**Statement of Basis/Proposed Plan for the Central Shops
Burning/Rubble Pit
(631-6G) (U)**

**WSRC-RP-96-142
Revision 1
October 24, 1996**

**SCDHEC and EPA Comments and SRS Responses on the
Statement of Basis/Proposed Plan for the
Central Shops Burning/Rubble Pit (631-6G) (U)
WSRC-RP-96-142, Revision 0, August 12, 1996
Received: September 23 & 24, 1996**

Figure 1 Location of BRP6G at the Savannah River Site

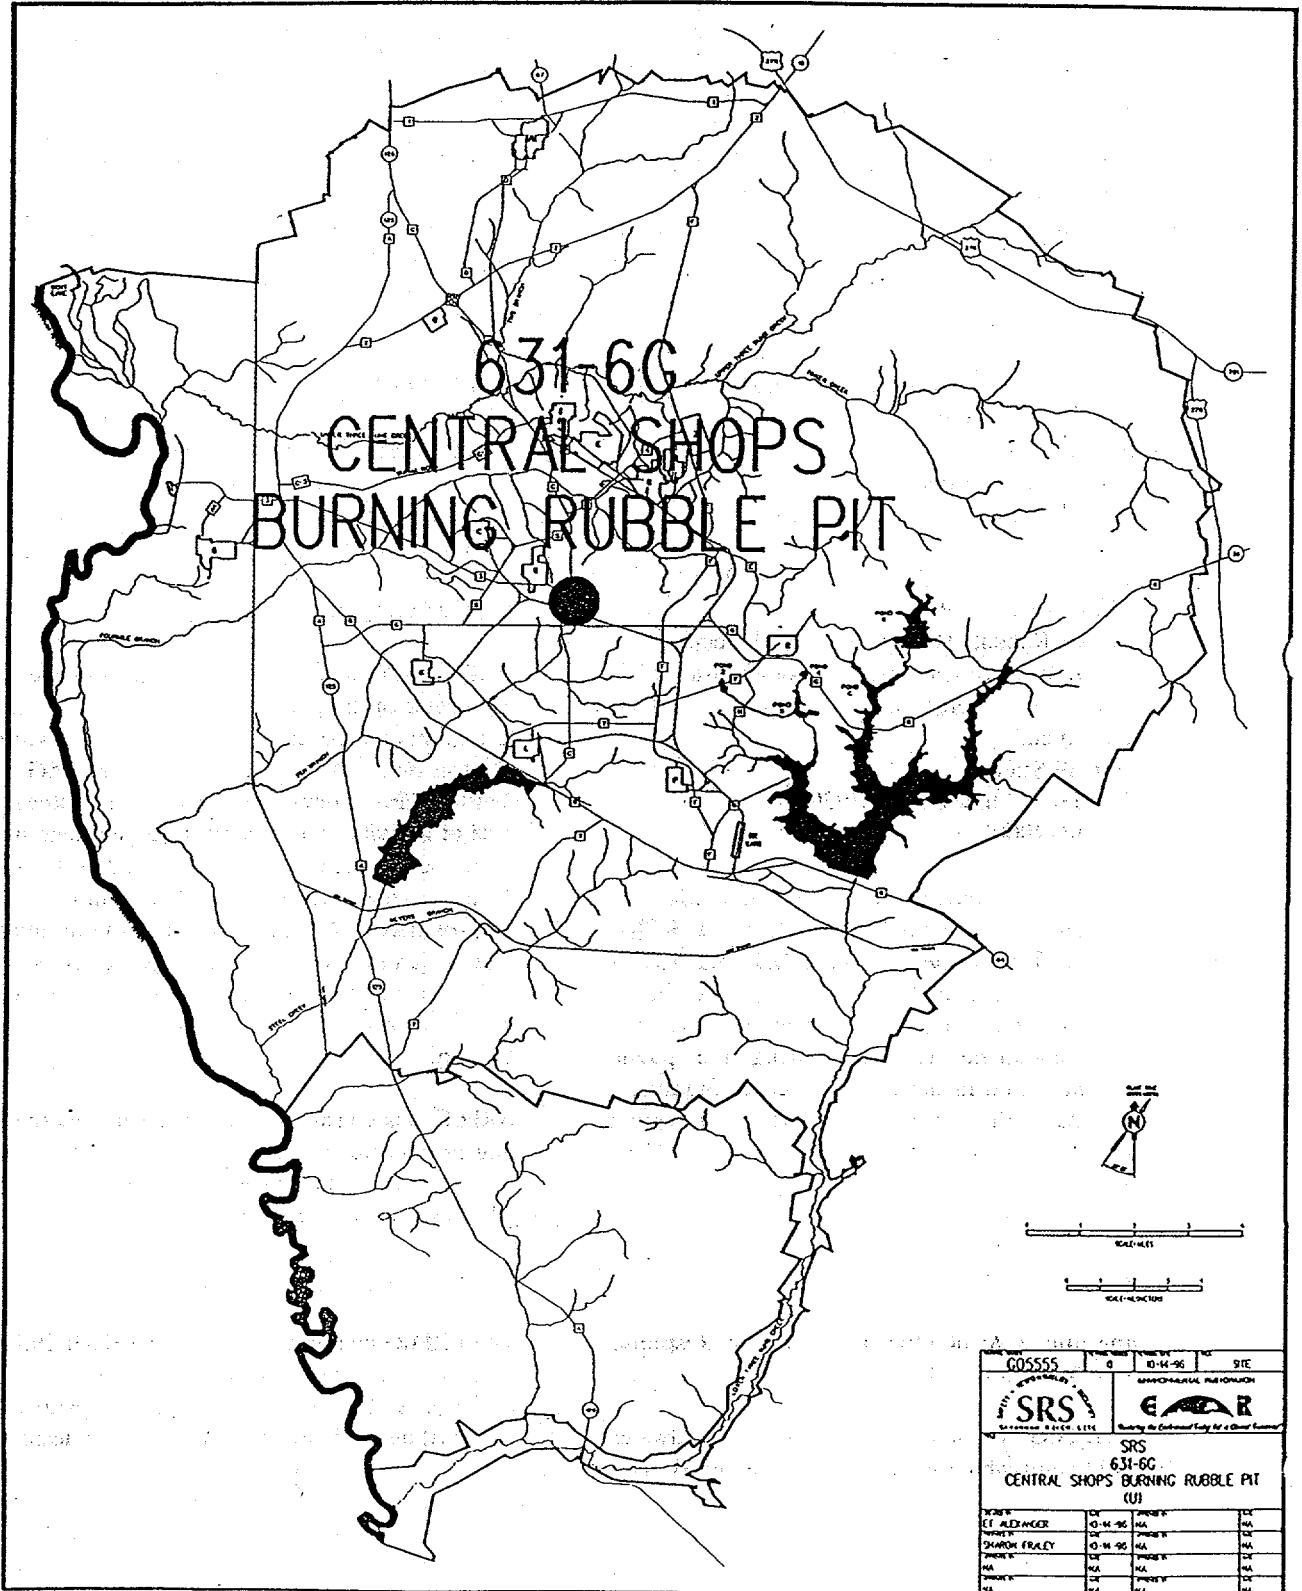
6. Page 4 of 11, Figure 1: It is unclear from the figure where this operable unit is located. Please make this operable unit location clearer to the reader.

Response 6. Agreed. A better label and arrow will be added to the drawing to clarify the location of the operable unit.
